**TO:** Mills City Council  
**FROM:** Megan Nelms, AICP, City Planner  
**DATE:** February 25, 2025  
**SUBJECT:** Vision Beyond Borders – Development Plan

**Case Number:** 24.04 DEV

**Vision Beyond Borders  
Commercial Development Plan**

# SITE PLAN FOR VISION BEYOND BORDERS IN THE CITY OF MILLS NATRONA COUNTY, WYOMING

**DRAINAGE PLAN**  
**VISION BEYOND BORDERS**  
**MILLS, WY**

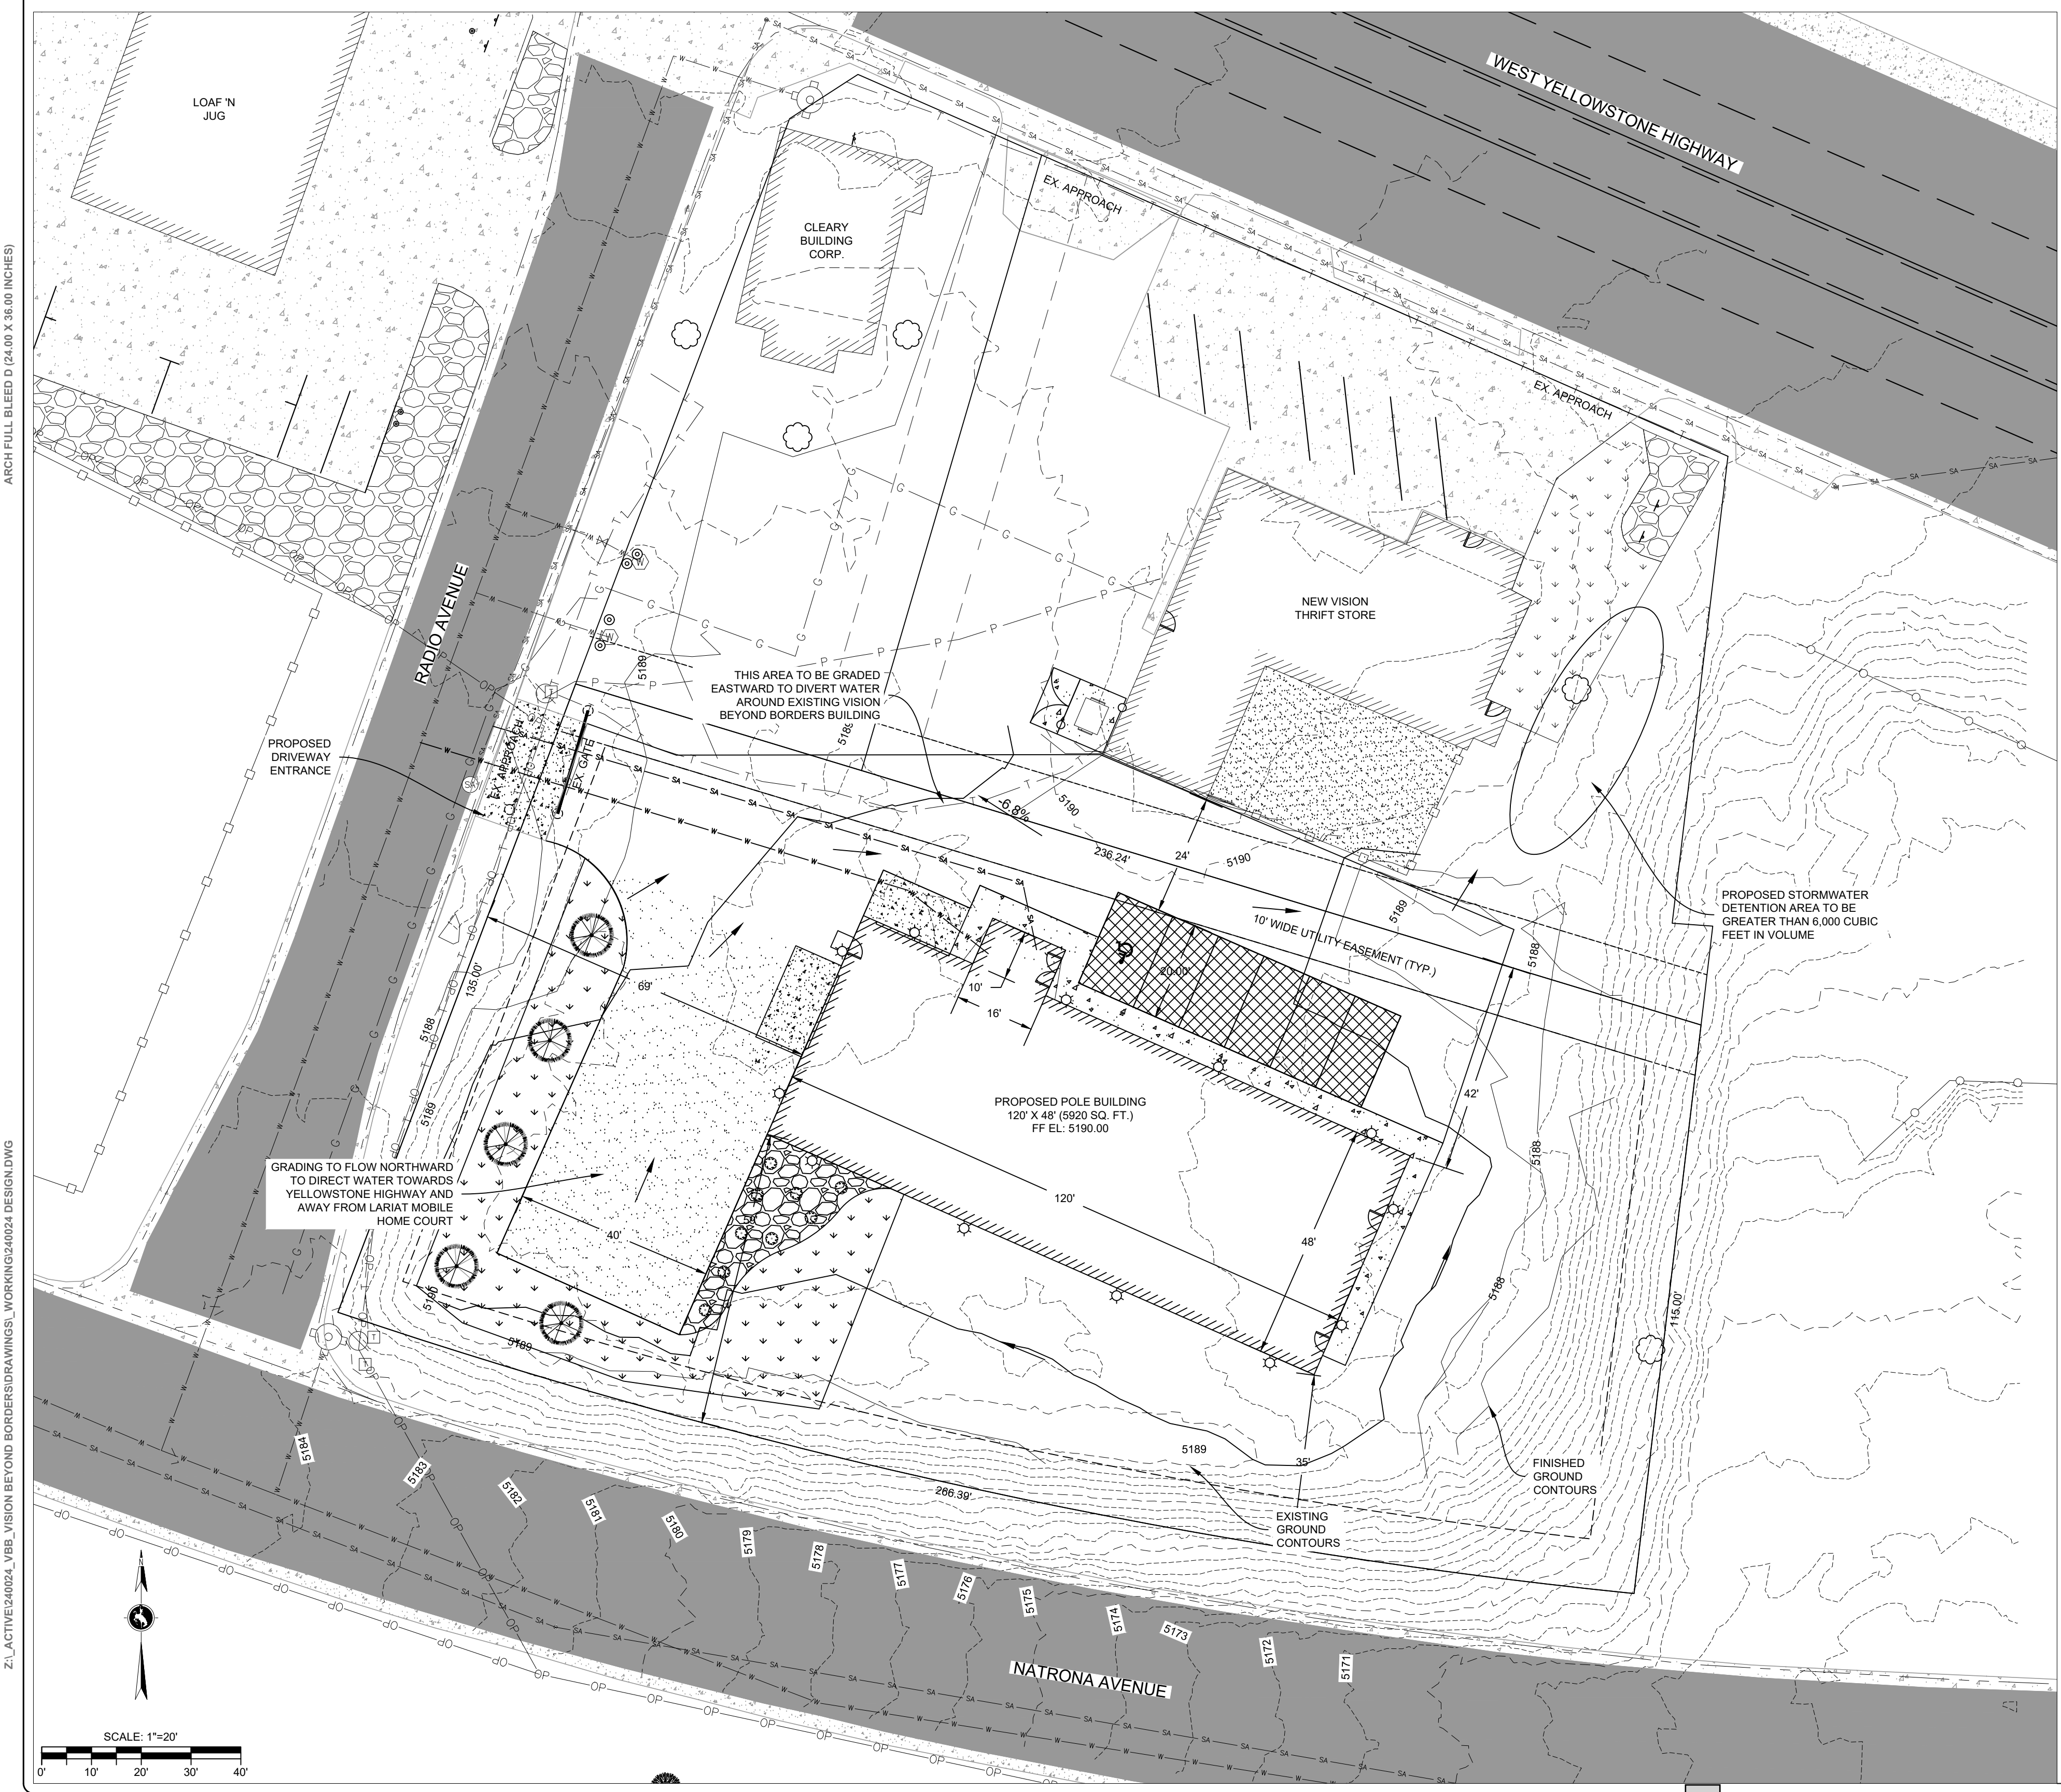
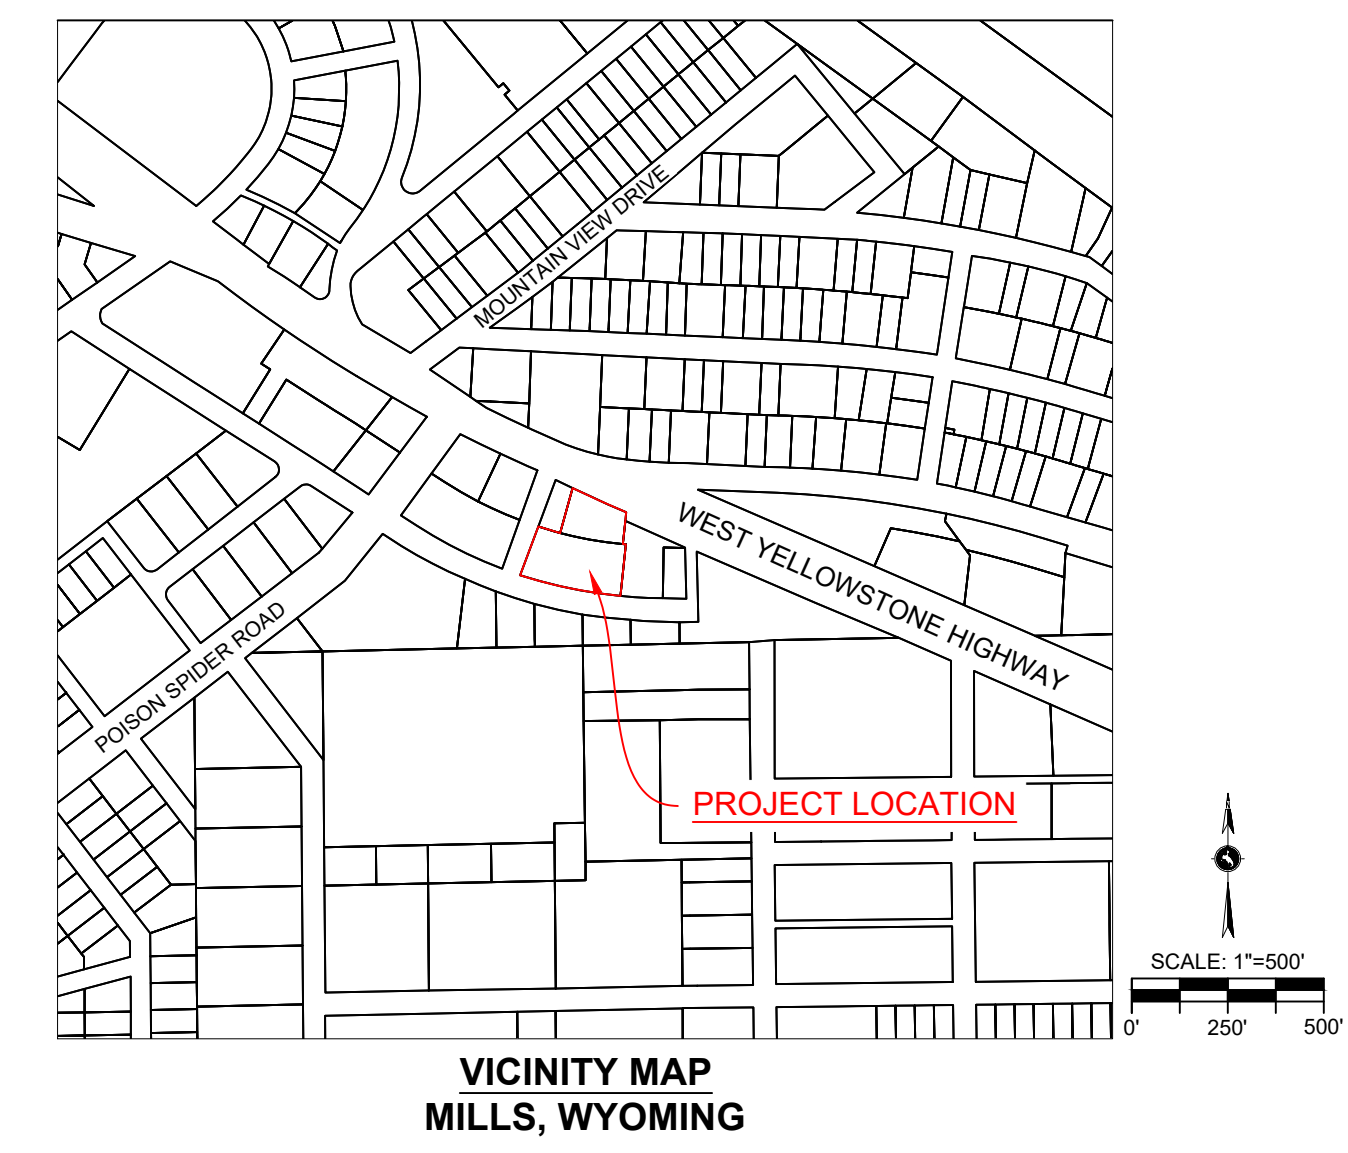
Chairman Gudger then asked if there were any questions from the commission. Vice Chairman Volzke questioned the updated drainage plan, saying it shows a small storm water detention area next to the thrift store, and he wants to confirm that a final drainage plan and design will be forthcoming. Megan confirmed that a final drainage plan would be required as part of the approval. Board Member Bryson commented there still wasn't a shared access easement shown for the access aisle between the two lots.

LANDSCAPE PLAN  
VISION BEYOND BORDERS  
MILLS, WY

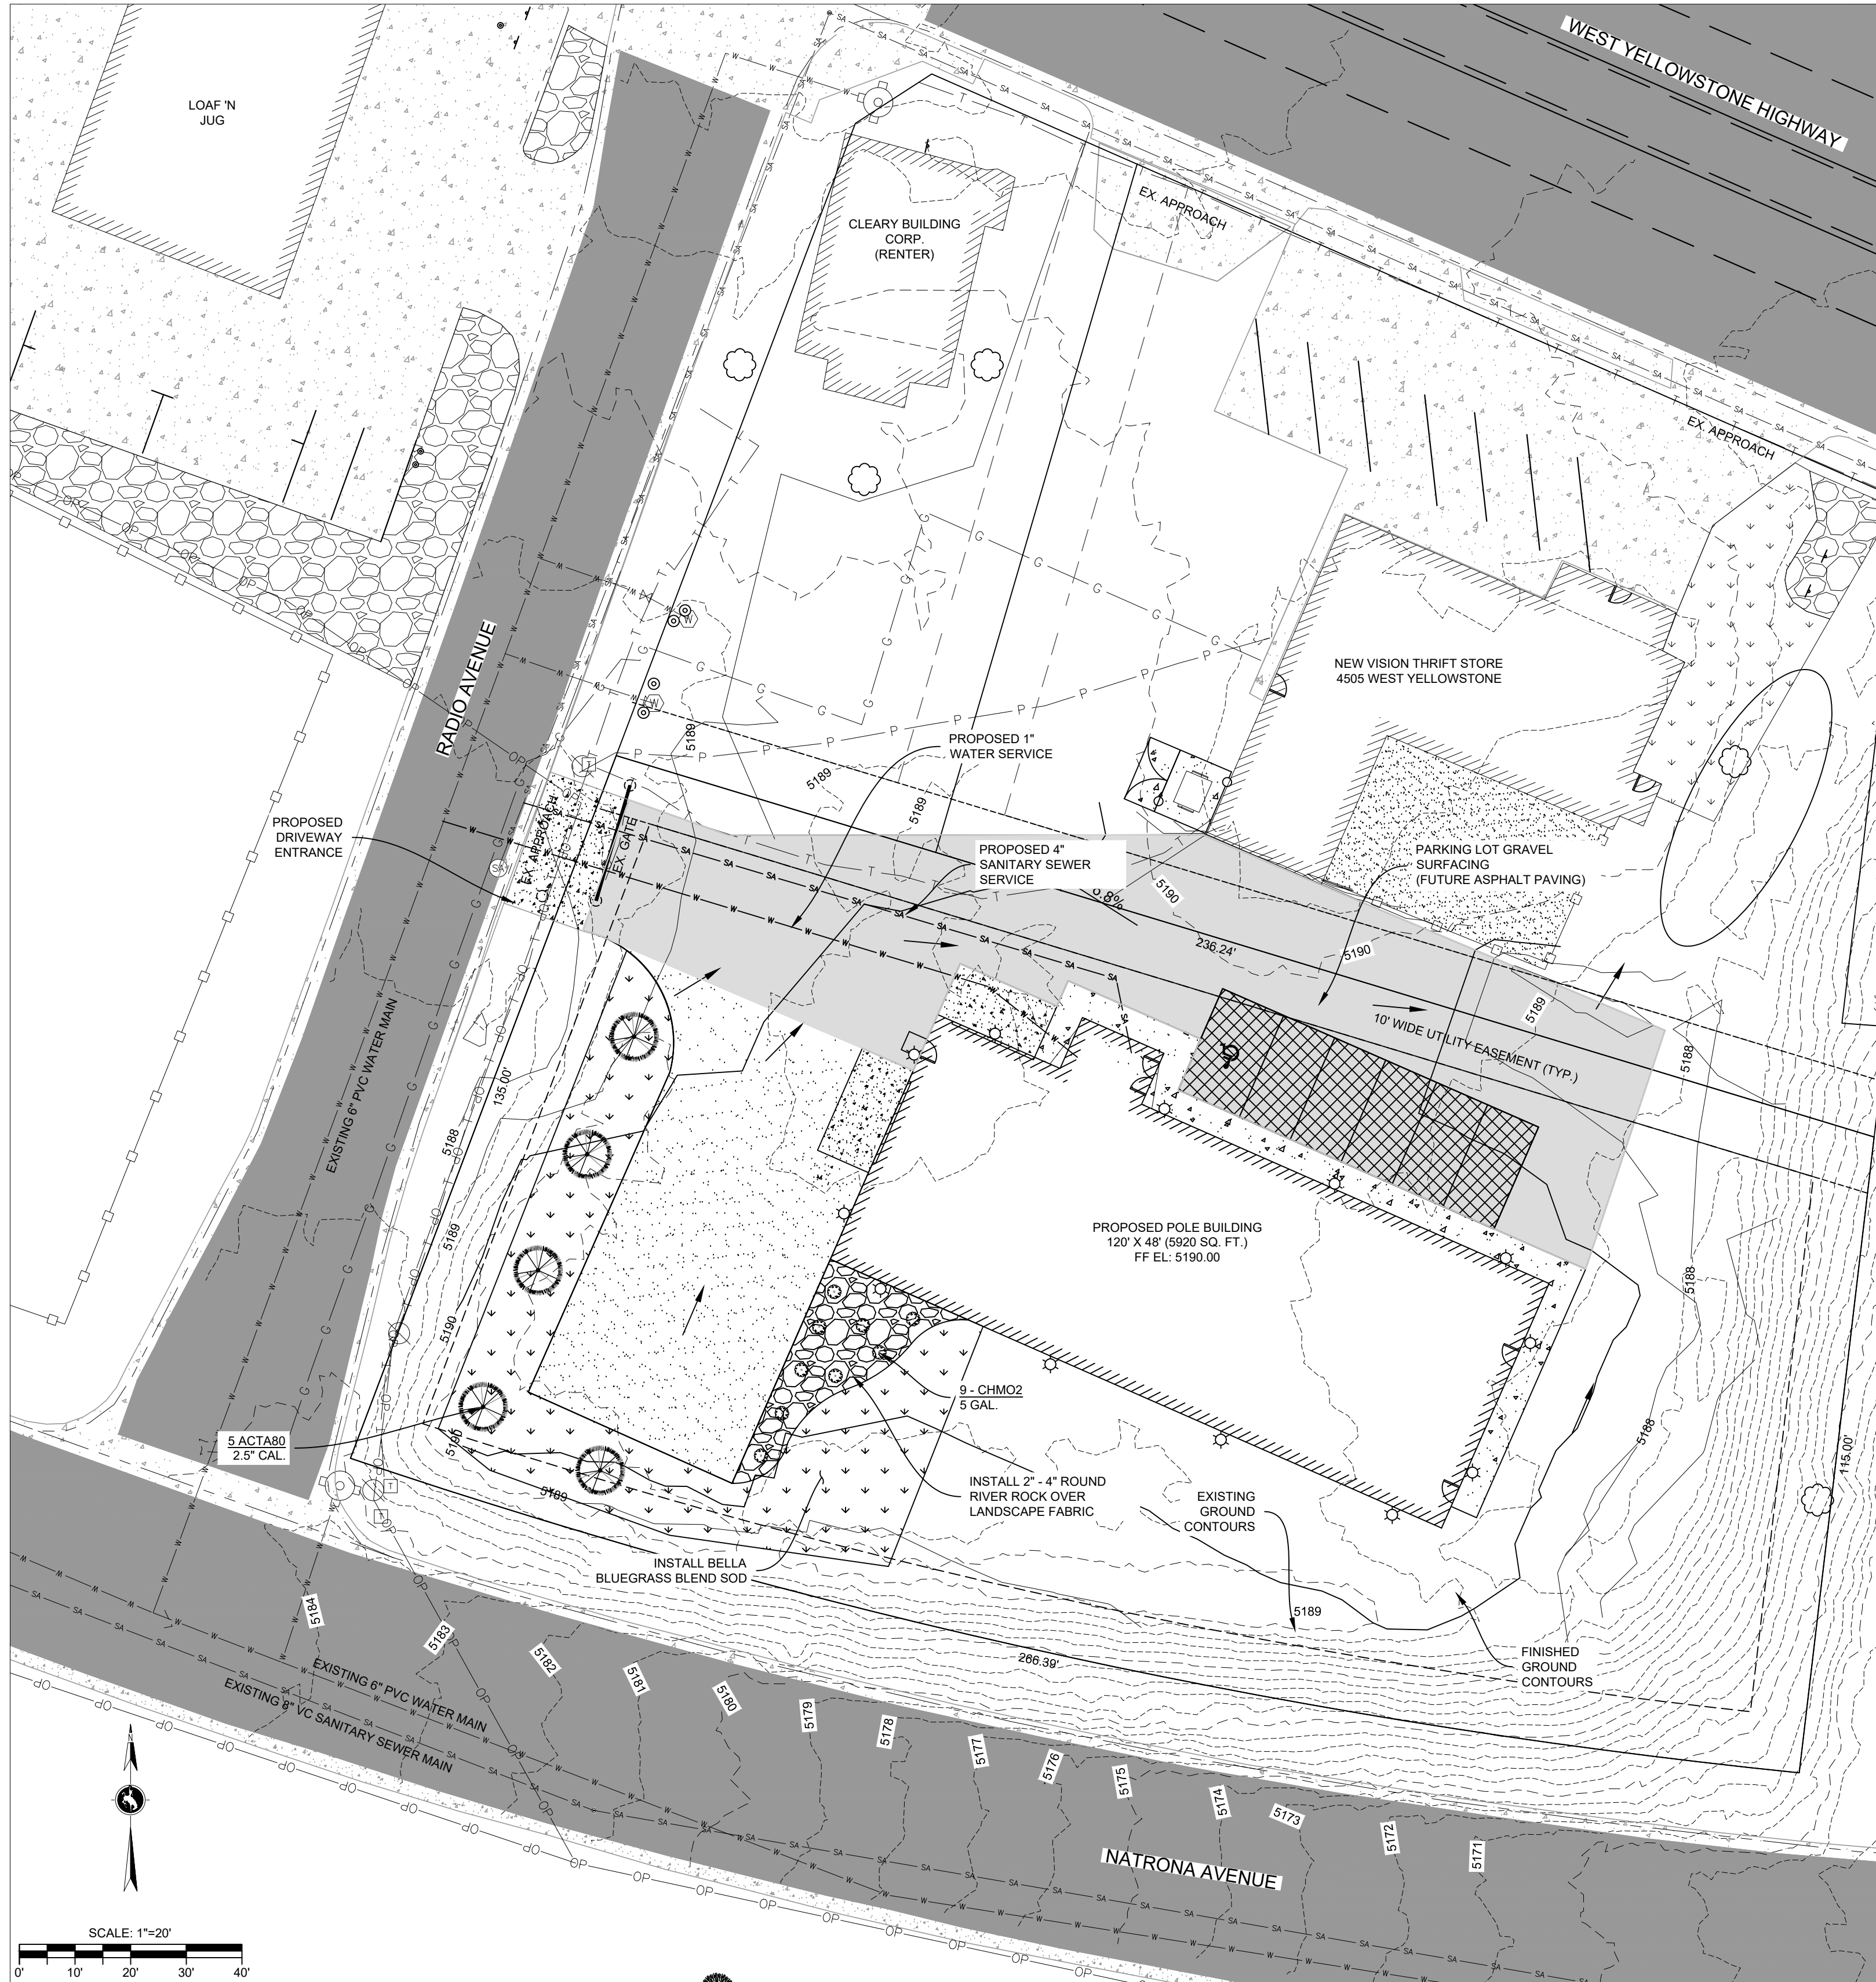
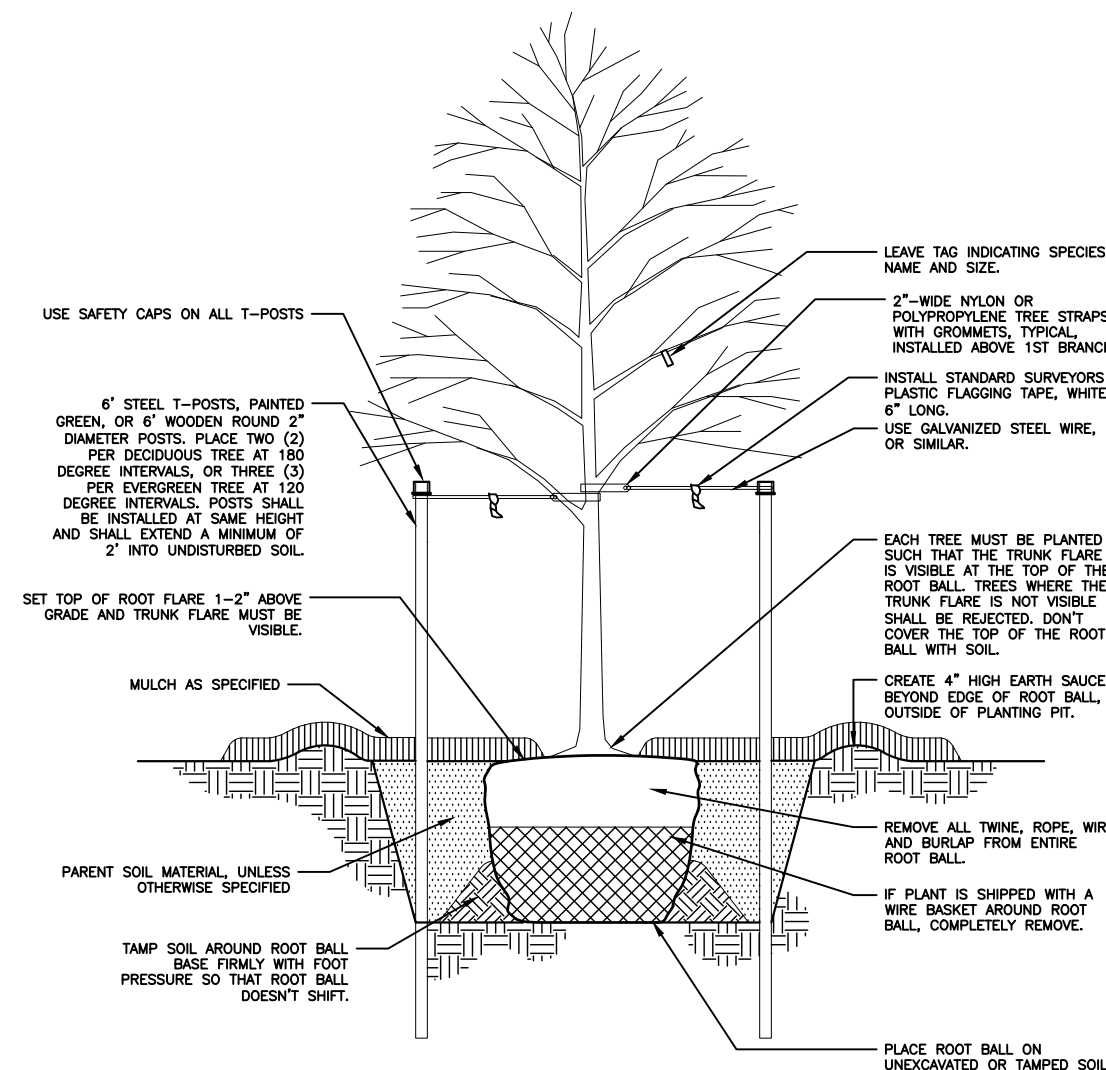
Board Member Bryson also had comments regarding the landscaping plan, stating he would like to see the landscaping closer to Yellowstone Highway, be recognizing that the landscaping is required to be installed on the lot being developed.
